Folder [20231105 Island View stormwater detention basin alternate design]

Alternate Stormwater Proposal for Island View

Ian Holyoake. 8 November 2023

Shortfalls and issues we have with the Pinnacle proposal:

Option B:

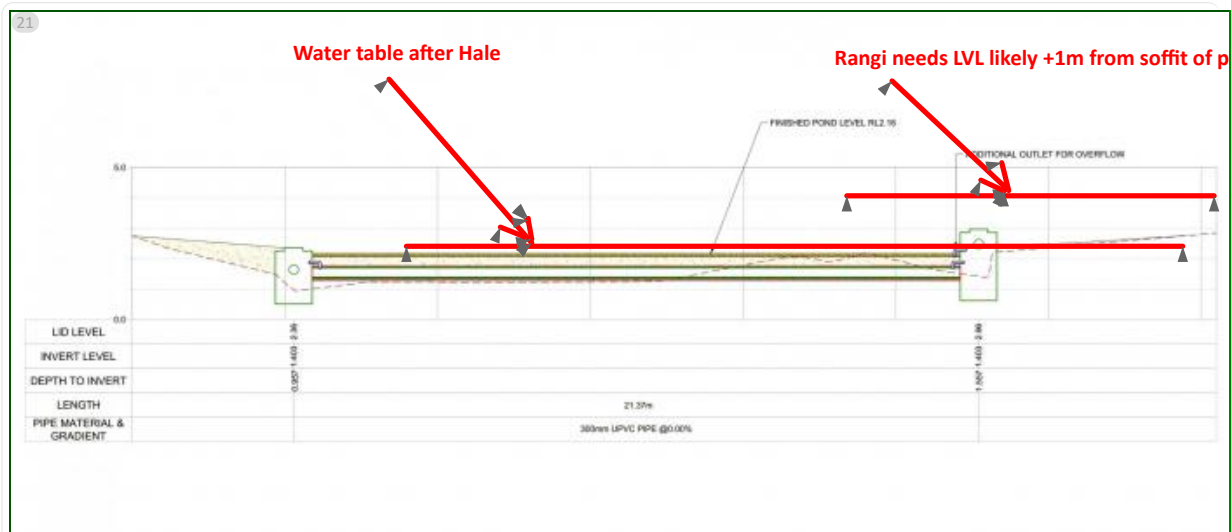
Bike or BMX track.

The kids use Island View park a lot, mainly younger kids with parental supervision.

A low skill track suitable for 4-10 years could be an ideal addition to the Reserve.

There may be enough room to have a higher skill subtrack.

The benefit of this is parents will be onsite supervising so maybe in part can be BMX low level challenge track and picnic areas

The track design is not to interfere with the general detention basin requirement or block off the overland flow path to the Ocean.
